Re:-Plot No.191,E/6,Ramswami Qr.

Re: Plot No. 191 Sheet E-6 Ramsaram Quarter

PLAN SHOWING PROPOSED BUILDING.

ON PLOT NO 191. E.6.

GROUND PLAN
PRAGJI STREET.

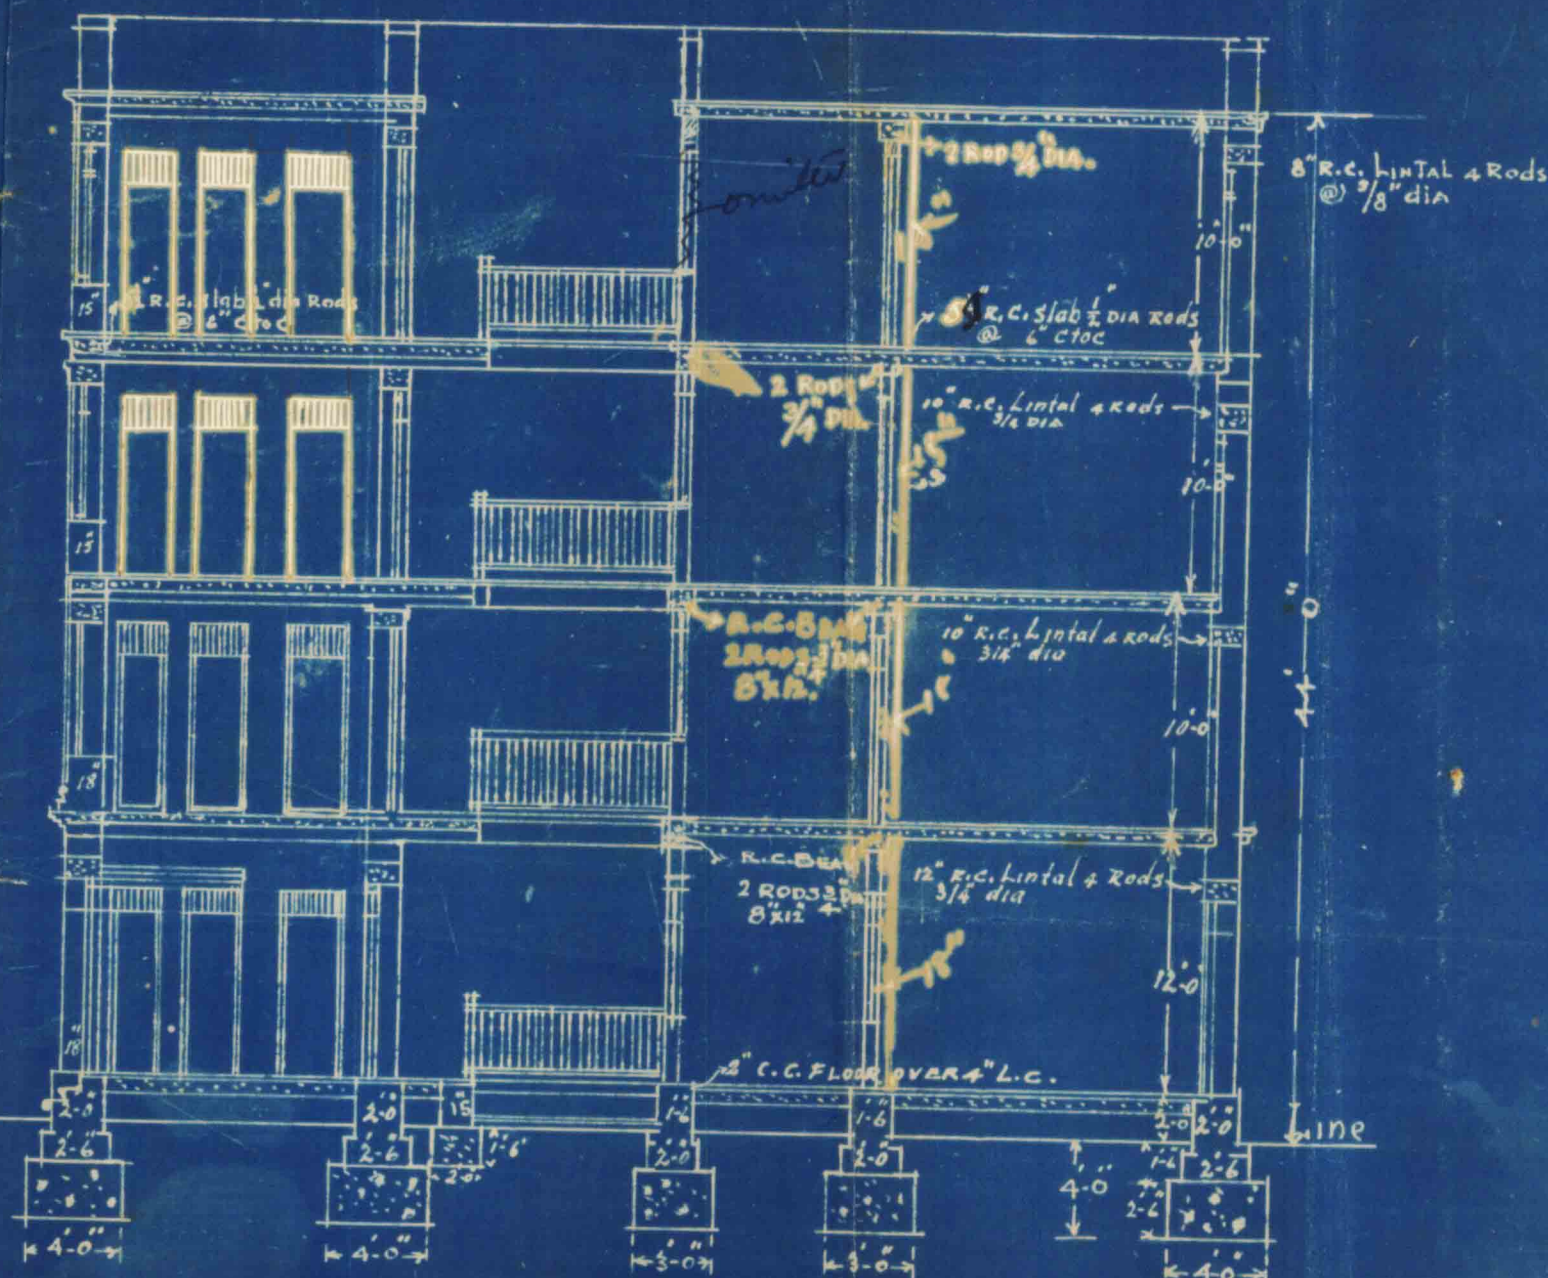
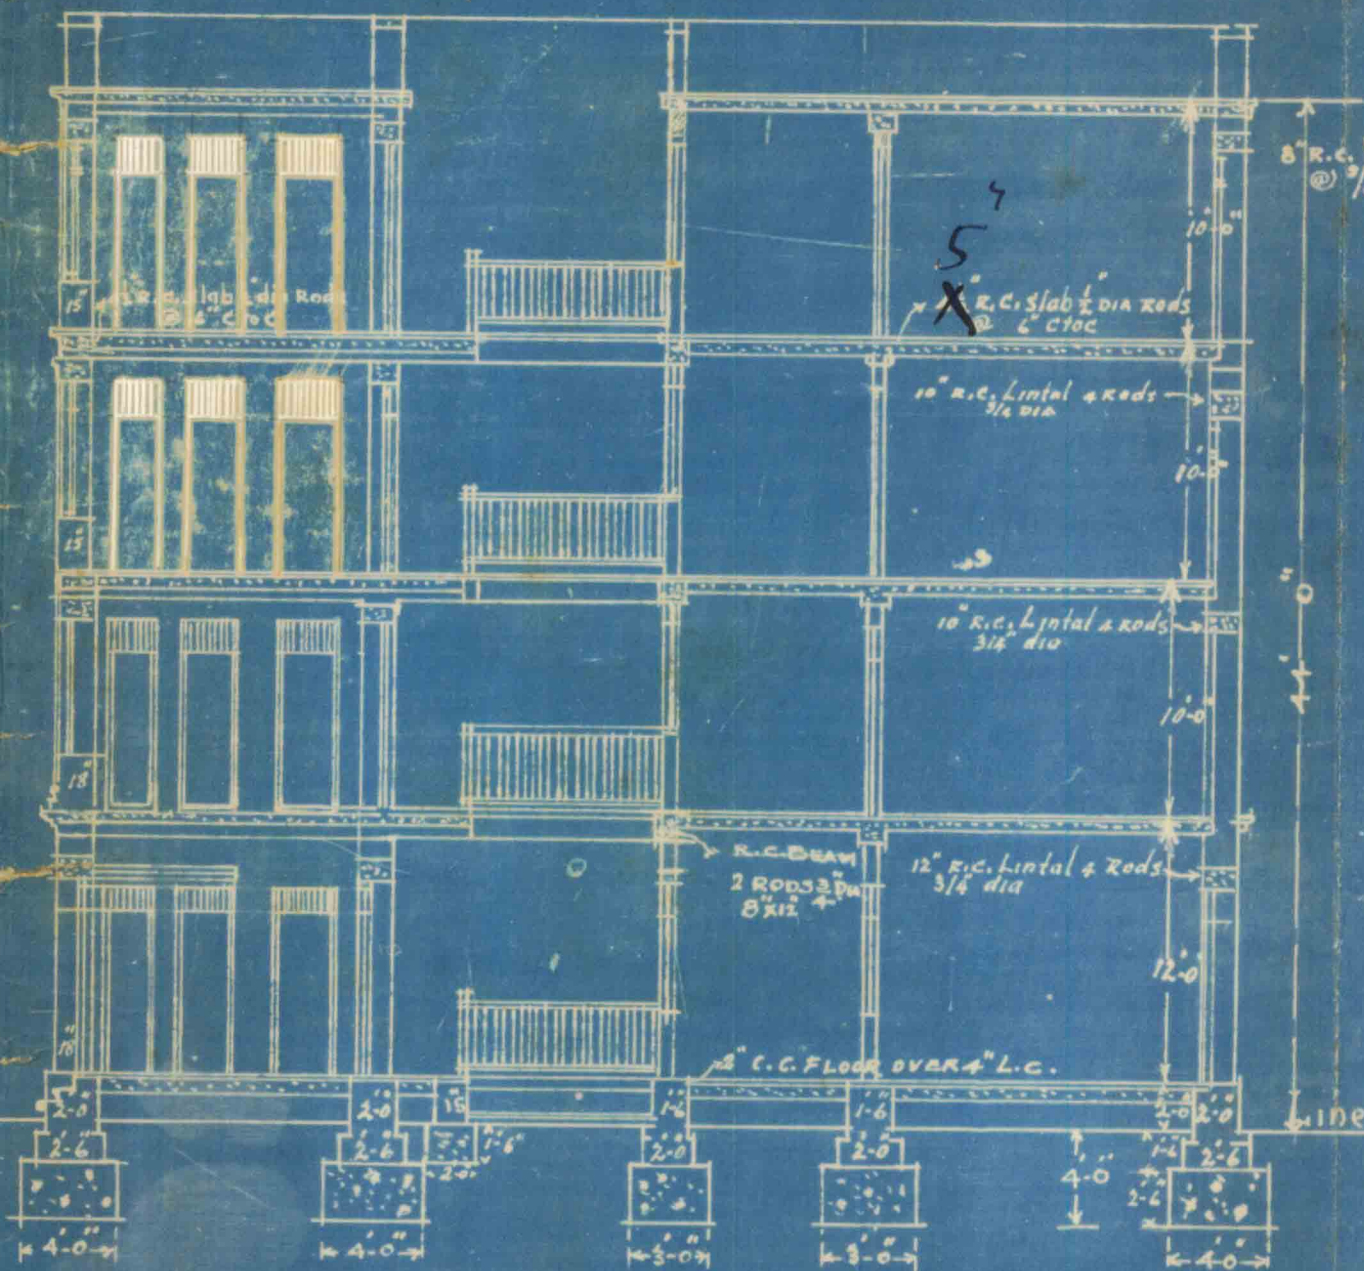
- (1) objection no 2. communicated to you under the office no. 2013117 dated 22/10/28 is not yet
- (2) Complied with
- (3) (1) Cross walls are not shown correctly on all the three copies
- (4)
- (5)
- (6)
- (7)
- (8)
- (9)

Bathrooms at the rear
Duck.

1. Bath room wall has been decreased in height
2. The Plot has been subdivided in City Survey office and a copy of Extract will be shown to you office in a day or two.
3. The cross wall has been made 18' wide instead of a partition wall.
4. North Point has been shown
5. Slab thickness has been increased as desired.

LONGITUDINAL SECTION ON LINE A.B.

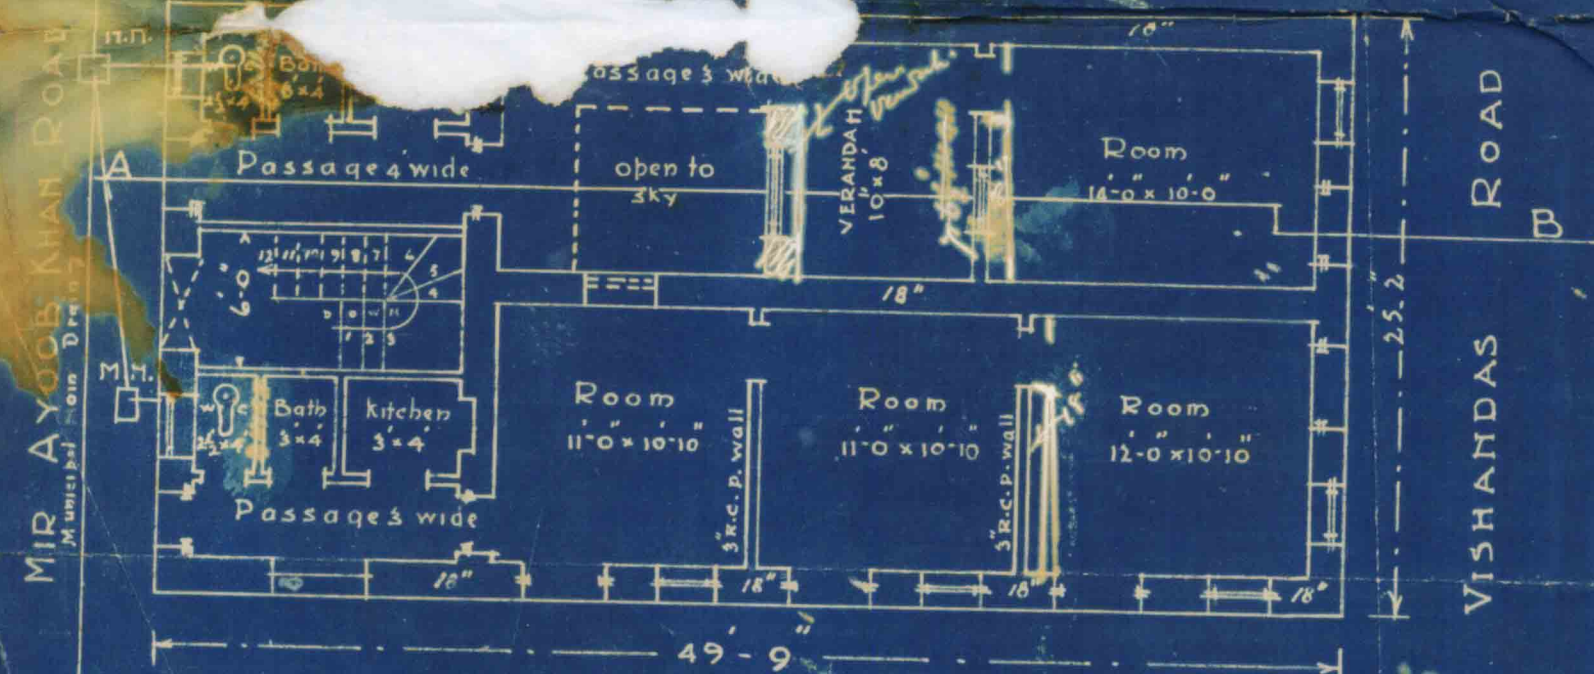
- (1) Bath rooms at the rear are dark.
- (2) The whole of the plot must be drawn on site plan with correct measurements.
- (3) Since the wall exceeds 30' in height, for 44' height of old the thickness of walls must be $23\frac{1}{2}"$ from the base for
- (4) a height of one storey, $18\frac{1}{2}"$ for next two storeys and 14" for the rest.
- (5) Wall A must be made 7'6" high.
- (6) North ^{line}~~wall~~ must be shown.
- (7) (6) Slab for 11' must be $5\frac{1}{2}"$ with reinforcement $\frac{1}{2}"$ rods 6" etc. & extra 2 rods $\frac{3}{4}"$ be provided below P. Wall.
- (8)
- (9)

(2) Since the wall exceeds 30' in length for a height of 44' of the bldg. the thickness of walls ^{shall be} 23 1/2" from the base for the height of one storey, 18 1/2" for next two stories and 14" for the rest.

SITE PLAN
SCALE 20=1

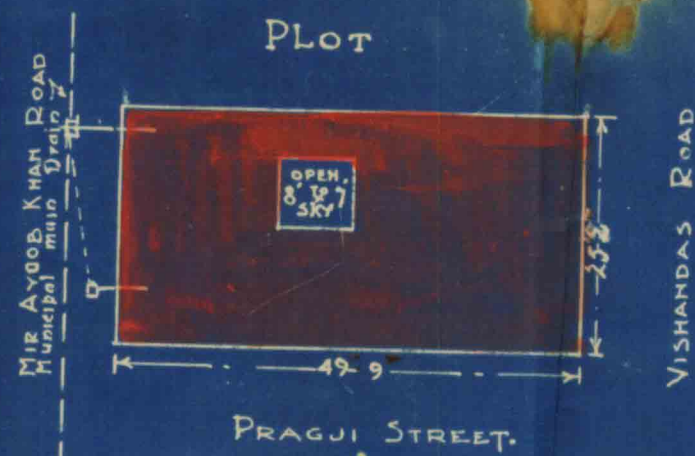
- (1) objection no. 2 communicated to you under 46 office no. 13117 dated 22/10/28 is not yet
- (2) complied with.
- (3) Cross walls are not shown correctly on all the three copies.
- (4)
- (5)
- (6)
- (7)
- (8)
- (9)

(1) whole plot must be drawn on site plan with correct measurements.
